**PART 8 – MAYNOOTH EASTERN RING ROAD – P82019-08**

**KILDARE COUNTY COUNCIL**

*Report for submission to the members, prepared in accordance with Part XI, Section 179, Sub-section (3)(a) and (3)(b) of the Planning and Development Act 2000 as amended.*

<b>Type of Development</b>	Maynooth Eastern Ring Road
<b>Site Address</b>	East of Maynooth Town, on lands between the R405 Celbridge Road and the R148 Leixlip Road.
<b>Development Proposed by</b>	Transportation & Public Safety Department, Kildare County Council
<b>Display Period</b>	<p>Plans and particulars on display at the offices of Kildare County Council from 14th May 2019 to 12th June 2019. These were also available to view on Kildare County Council's website</p> <p>A Newspaper Notice published in the Leinster Leader and The Nationalist on the 14th May 2019. A Notice was also published in the Liffey Champion on 18th May 2019.</p> <p>Site Notices were erected at the site location on the 14th May 2019</p> <p>Submissions could be made in writing or online on or before 17:00 on Thursday 27 June 2019.</p>
<b>Submissions/Observations</b>	33 no. public submissions received.
<b>Part 8 Reference Number</b>	<b>P8 2019 - 08</b>

### **Noise Barrier at Griffin Rath**

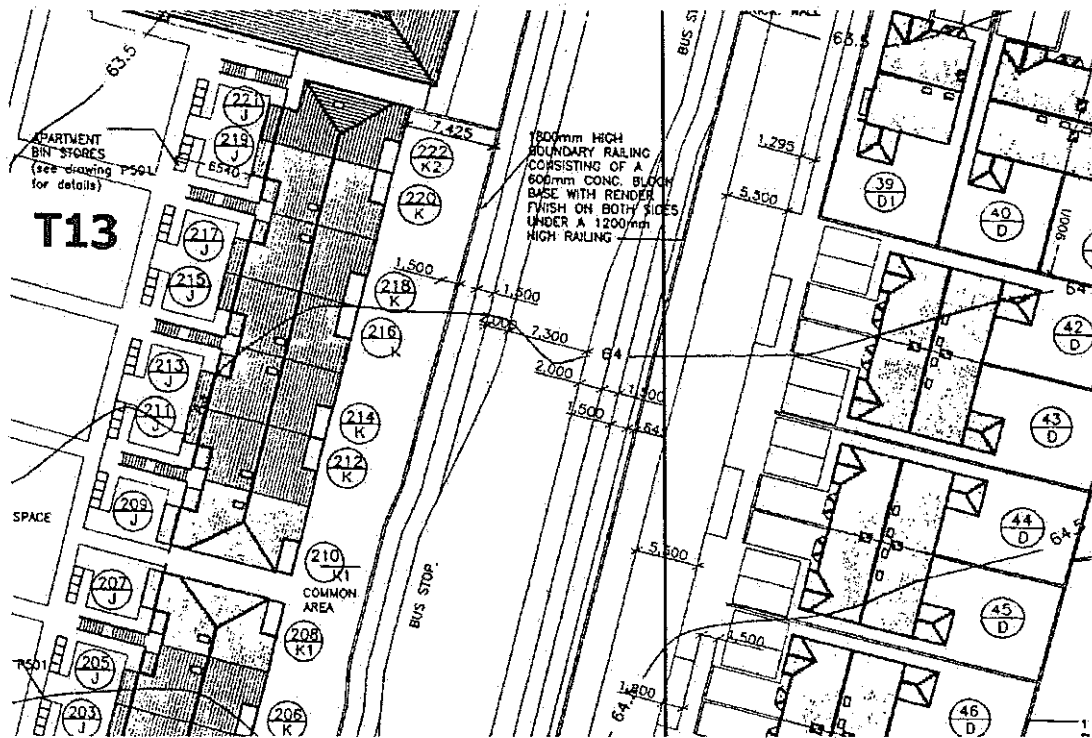
Serious concerns have been raised by the Planning Department regarding the construction of 3m and 2.5m high noise barrier walls in the area of Griffin Rath Road, between Griffin Rath Hall and Griffin Rath Manor. These walls will be on both sides of the road and will create an inhospitable urban environment, they will result in a public open space at the entrance to the estate with a wall on three sides. Although it is acknowledged that the construction of these walls arose in response to issues raised in the noise survey, it is considered that this recommendation fails to take into account the fact that the permitted layout and constructed development had anticipated that this stretch of roadway would be part of the Maynooth Eastern Ring Road and that, even in the submissions made, there is no suggestion of an expectation that this roadway would remain a cul de sac indefinitely.

The construction of noise barrier walls as proposed is not acceptable in an urban area and alternative noise mitigation should be proposed, including additional planting and narrower road section or other traffic calming measures. The relocation of the proposed bus stop may also be considered as a noise mitigation measure, any proposed relocation should be within 250m of the current proposed location.

At the Maynooth Municipal District Meeting on 29<sup>th</sup> July, 2019, the members resolved that the Maynooth Eastern Ring Road be carried out with the modifications as recommended in the Chief Executive's Report except modification No. 7, which the members varied as follows:

'That a two meter high stone wall be built at Griffin Rath Hall and Griffin Rath Manor with mature planting as a suitable noise barrier. That a table top ramp is installed at the entrance to Griffin Rath Hall'.
